Samurai Heater Box / Cowl Vent

Aqualu provides the option to cut the cowl vent slats and heater drain holes on the Samurai #6000 SWB, #6010 LWB or #6020 13" stretch custom cab.

Cowl Vent holes

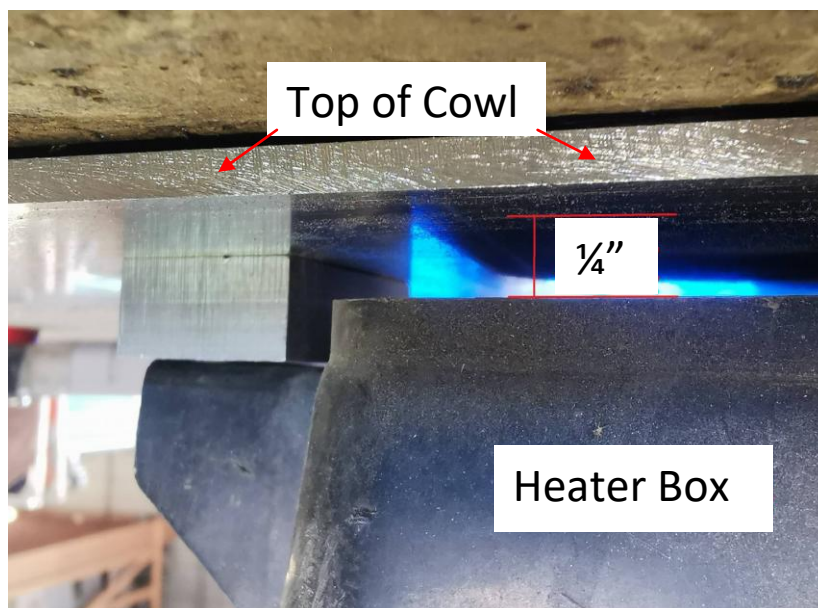
These vent slots and heater hose pass-through holes can be eliminated to keep debris from falling into the heater box. With the vent holes removed, the heater re-circulates cabin air rather than pulling fresh air into the cabin.

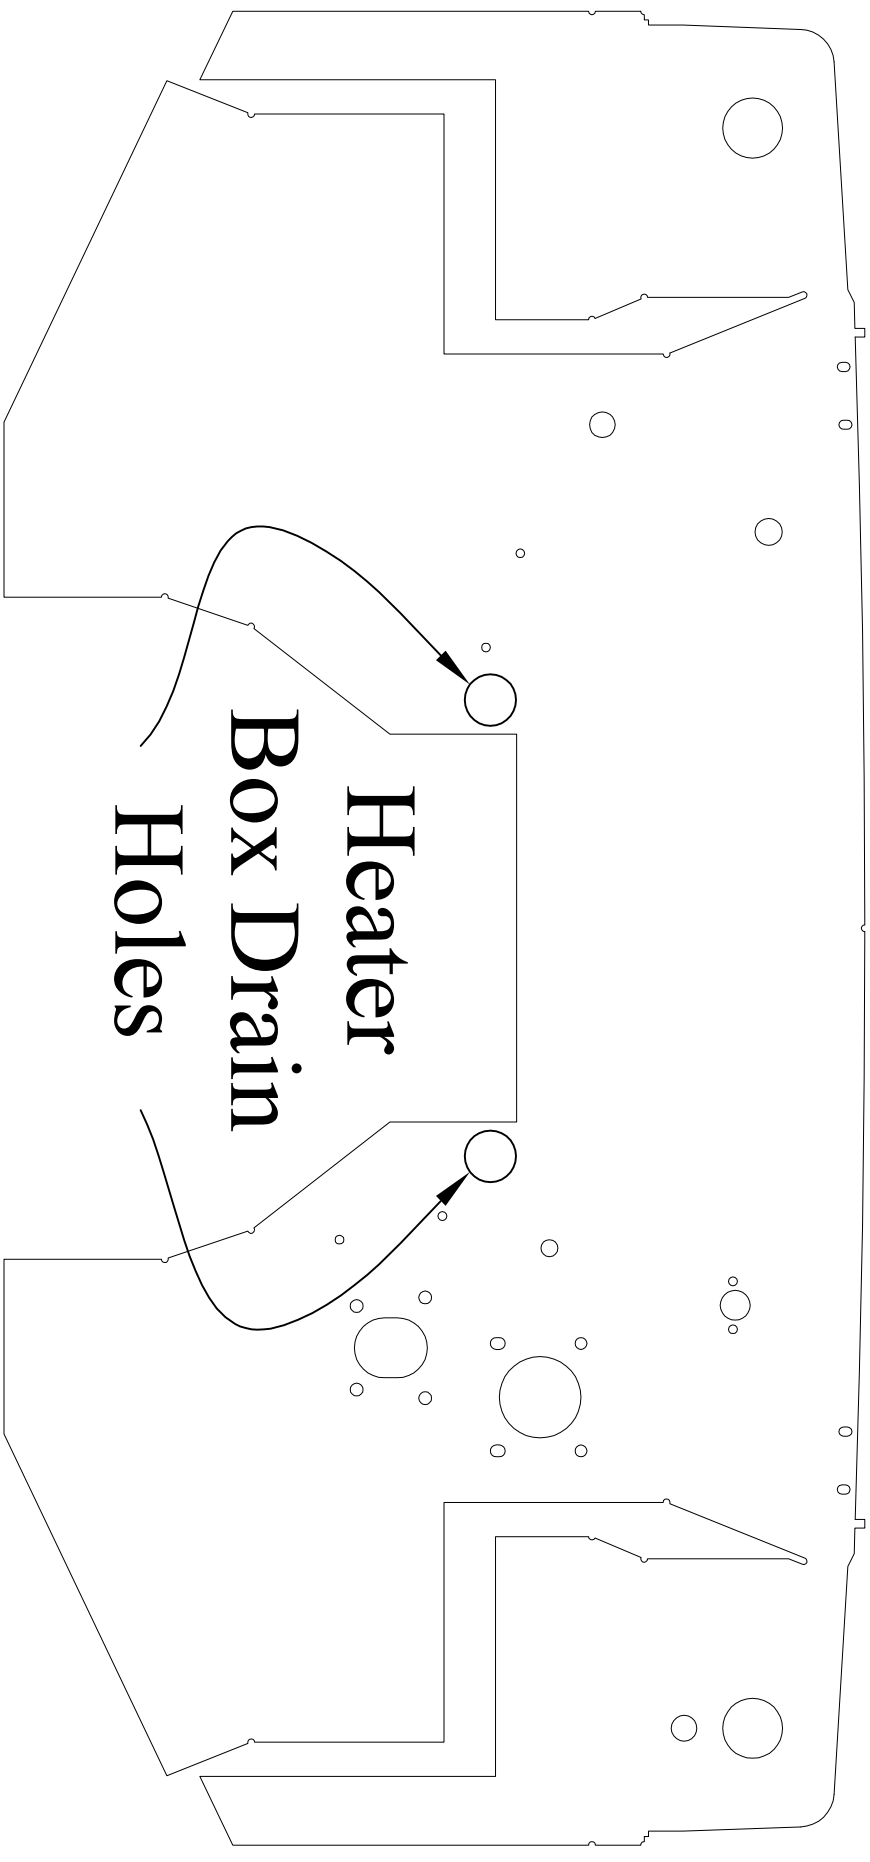
The following outlines what airbox modifications need to be made to install the heater box when vent holes are not cut:

Heater box gasket must be removed (highlighted in red below)

This creates a gap approximately 1/4" tall, allowing passenger cabin air to enter the heater box before re-circulating to the outlets.
